THE ILLINOIS STATE TOLL HIGHWAY AUTHORITY

DESIGN BULLETIN No. 20-01

SUBJECT: Sign Structure Base Sheets and Standard Drawings Revisions

The 720 OHS Base Sheets and Standard Drawing Section F Sign Structure have been revised per the following (attached are examples of the changes shown in 729 OHS Sheets 1 and 3 and 730 OHS Sheets 1, 3 and 4 of Base Sheets):

BASE DRAWING M-OHS-729
SHEET 1 OF 8

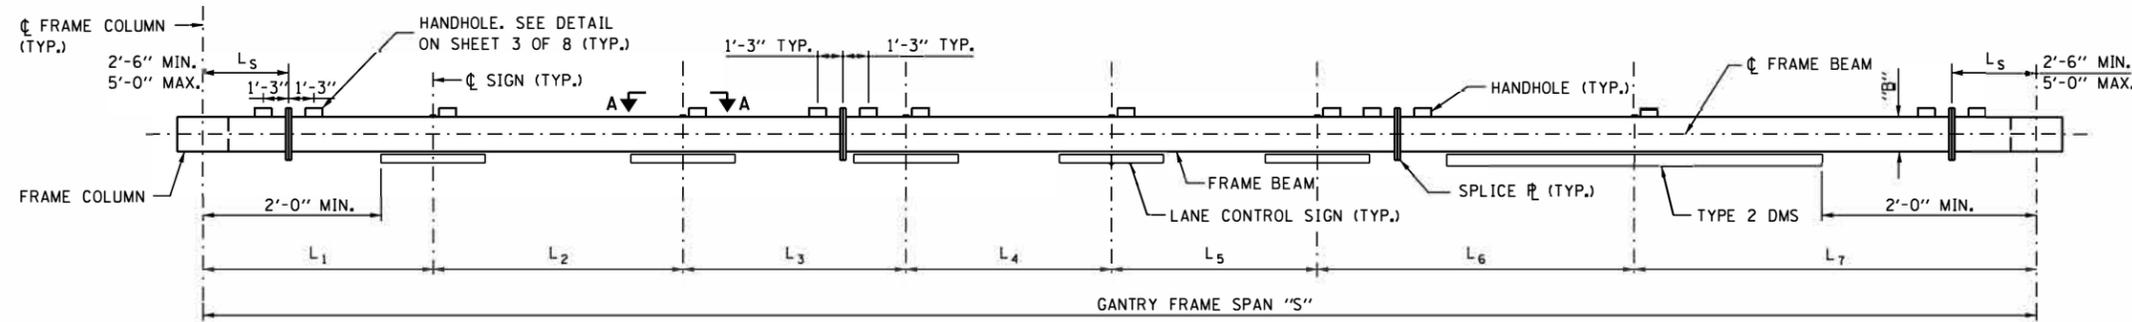
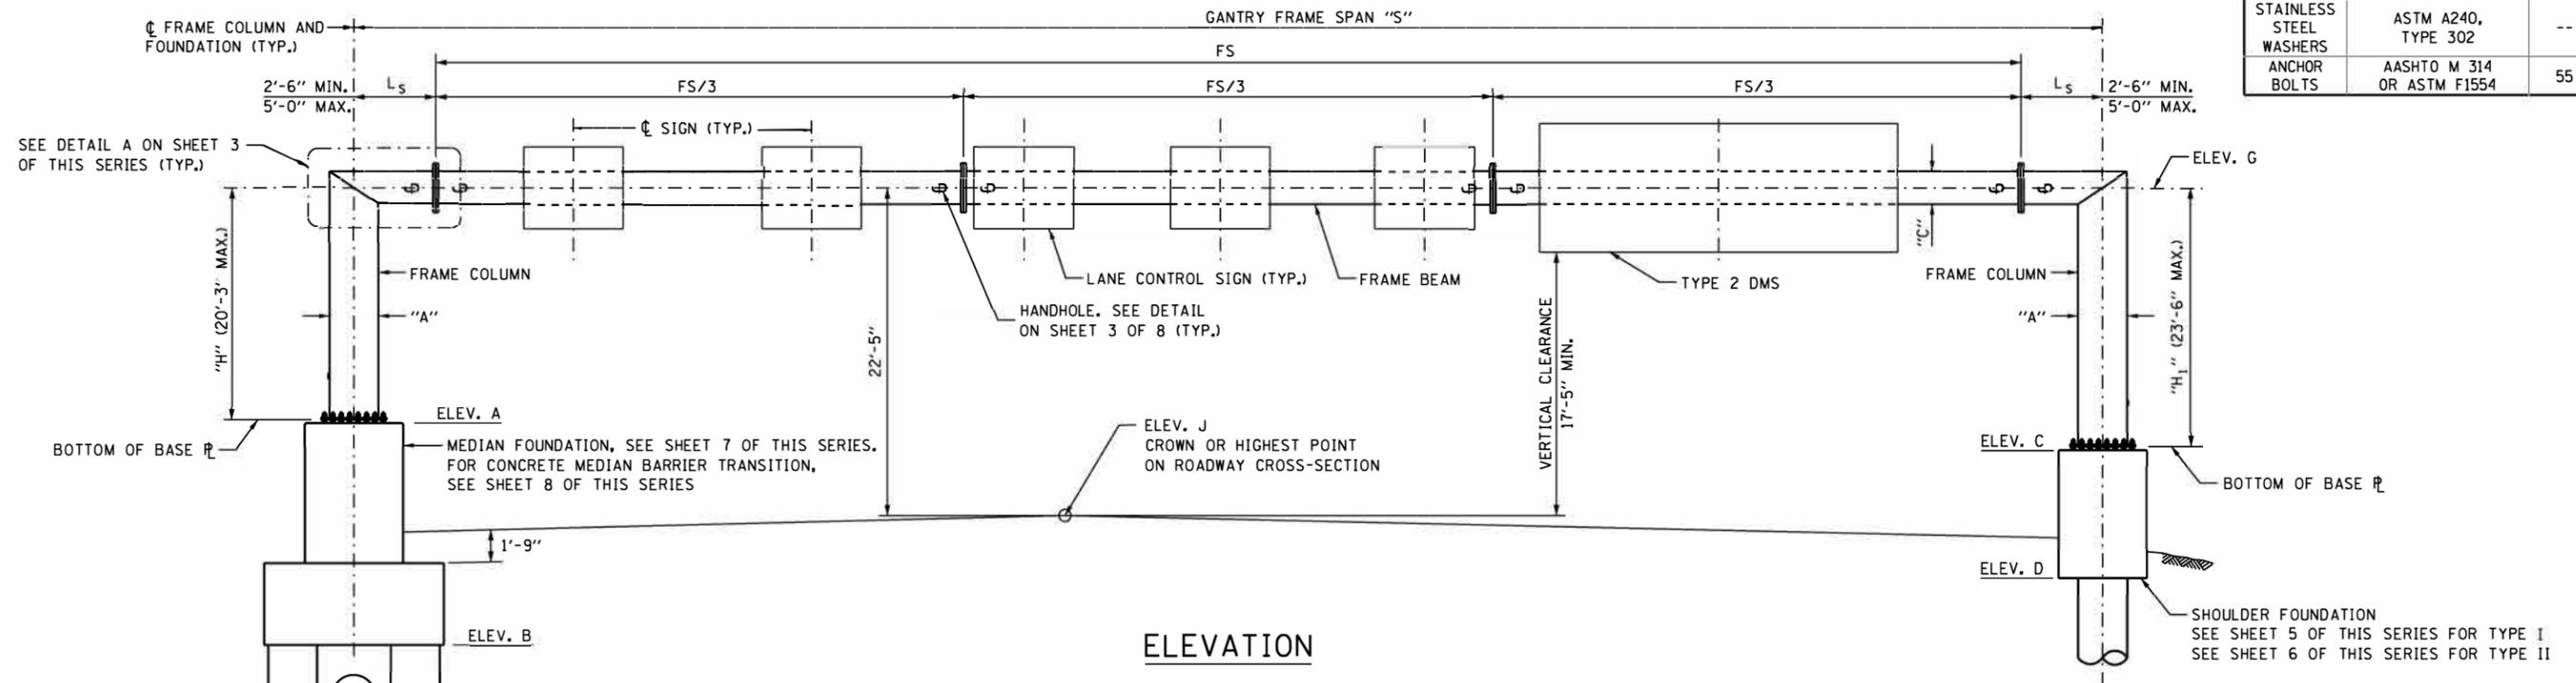
Handhole Openings: During gantry construction, difficulties were identified with pulling cable around the splices because the LCS (Lane Control Signs) were pre-assembled on the beam prior to gantry installation. Base Sheets and Standard Drawings have been revised adding and modifying new handhole openings on each side of splices along the horizontal beam for ease of construction and feeding of cables.

Splice Bolt Tightening: Maintenance had identified loose bolts in the splice plates on multiple gantry warning structures over live traffic. Base Sheets and Standard Drawings have been revised adding procedure notes for proper bolt tightening after initial snug tight has been achieved at splices.

Base Plate Anchors: During inspection of base plate anchors, loose nuts were identified on multiple overhead sign structures. Base Sheets and Standard Drawings have been revised adding procedure notes for proper installation of double nuts to be used instead of one nut shown in the previous details.
